**Deadline 7 submission to Planning Inspectorate, National Infrastructure Planning: Ref. TR010025**

Prepared by Dr. G.M. Reeves for the **Stonehenge Alliance. Ref.2001870**

**Part one: Response to Section 11.2 “Comments on Written Representations Report”** in Highways England’s document REP5-003 (“Comments on any further Information Requested by the ExA and Received at Deadline 4”)

**Part two: Summary of fundamental failures in Highways England’s ground characterisation of proposed A303 Tunnel and Road Project with ref to REP5-003, Section 11.1, Oral Submissions**

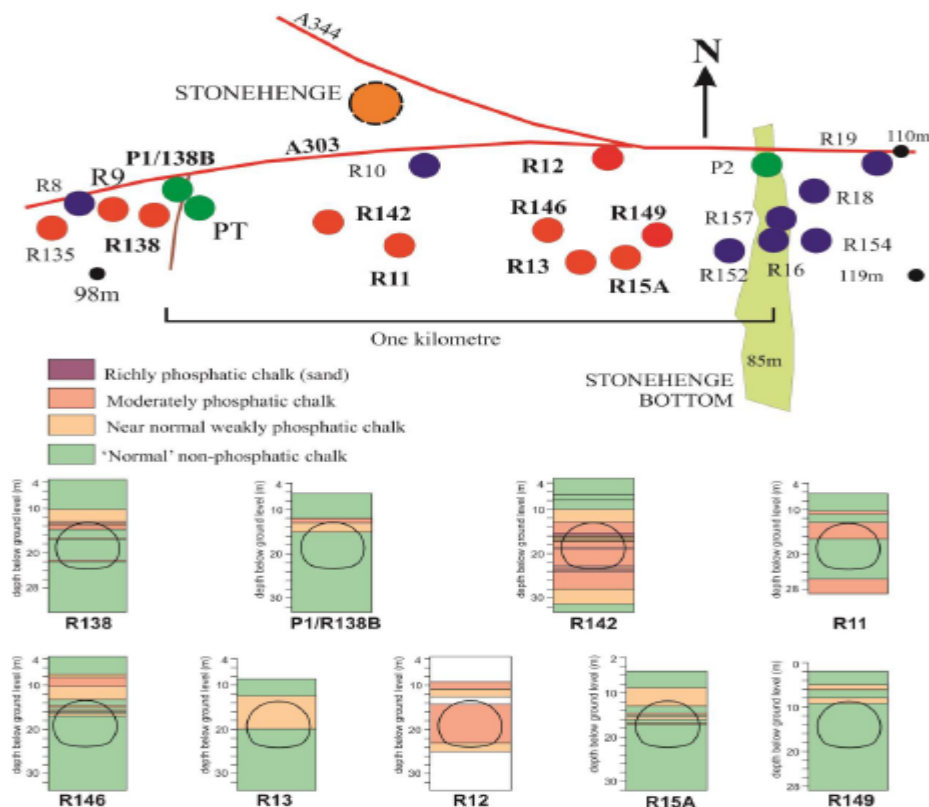
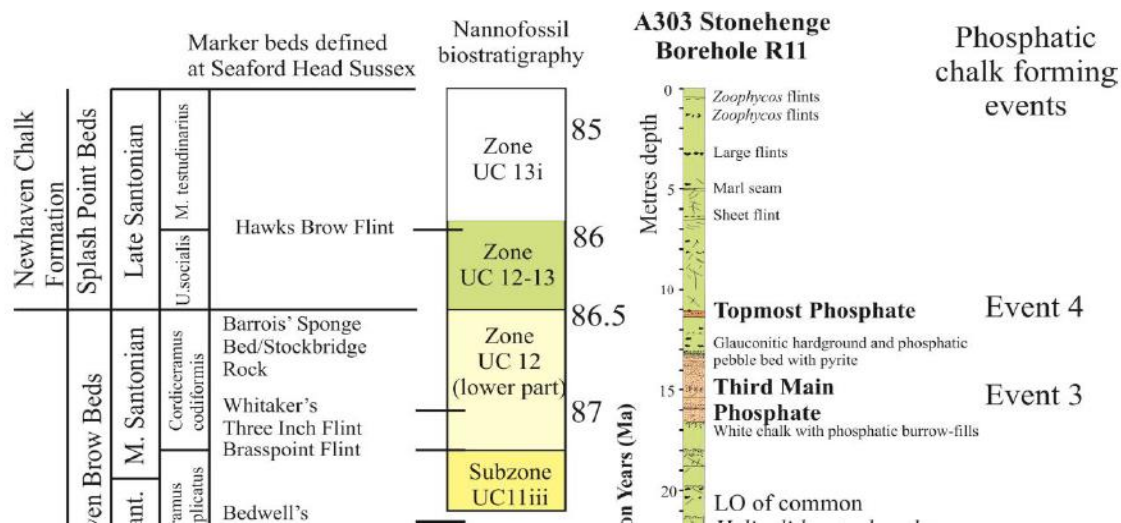
As displayed in Mortimore et al., 2017 ( Figure 25, reproduced below), at various borehole locations and depths along the original proposed tunnel line (slightly to the south along the western portion of the current proposed tunnel route), weak Phosphatic Seaford Chalk was identified as a potential instability problem along the tunnel line and especially at and above the tunnel face.

(From Mortimore et al., 2017, Figure 7 in part)

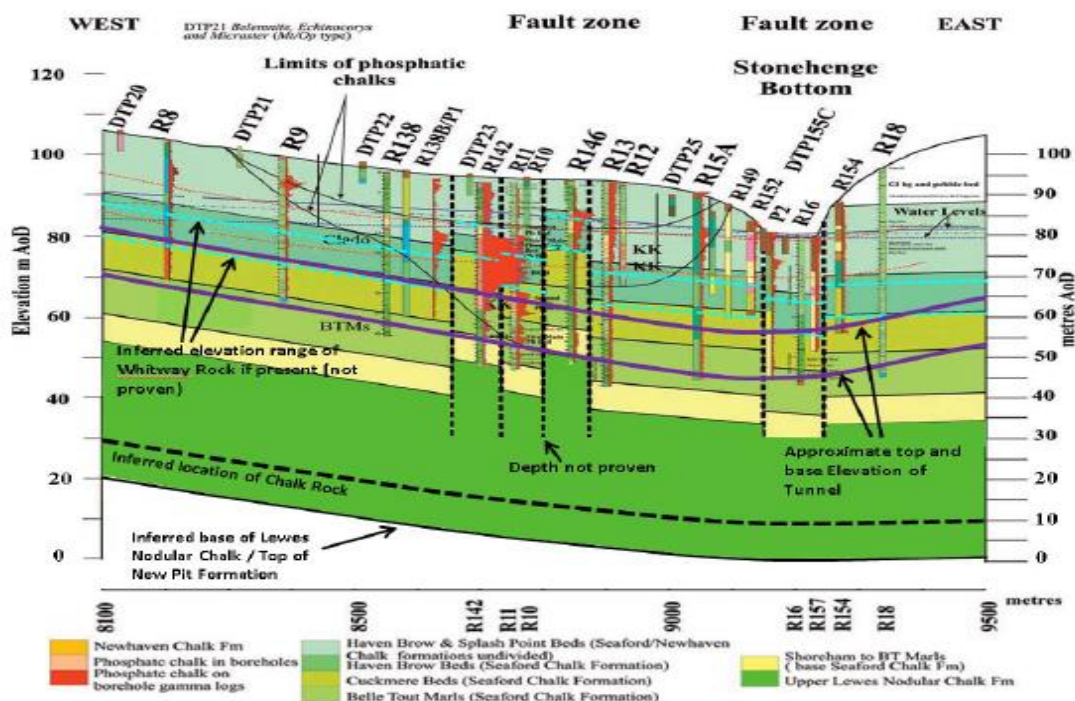
The Barrois' Sponge Bed/Stockbridge/Whitway Rock Formation level, which appears to control much horizontal groundwater flow eastwards towards Amesbury and beyond (see GM Reeves, comments on Blick Mead and Amesbury Abbey Springs etc. in SA Submission REP6-064, at Deadline 6, dated 25<sup>th</sup> July 2019), can be positively identified in both Borehole R501 (at approximately 20 metres depth- Zero RQD -as shown in GM Reeves Session 4 Presentation (REP4-088): Slides 6,7 and 8; Borehole R501, 18.75 to 21m) and also as an equivalent fractured bed in the earlier drilled borehole R18, at approx. 24.00 to 33.00m depth - c.66m AOD, coincident with a spike in the DTH - porosity log. The sequence containing this horizon is as shown below (Mortimore et al., 2017, Figure 7).

NB. Standing Groundwater Levels are reported at or about this horizon level, i.e., at 23.10m BGL in a zone of steeply dipping open fractures, as reported on the drill logs and shown in core box photos.
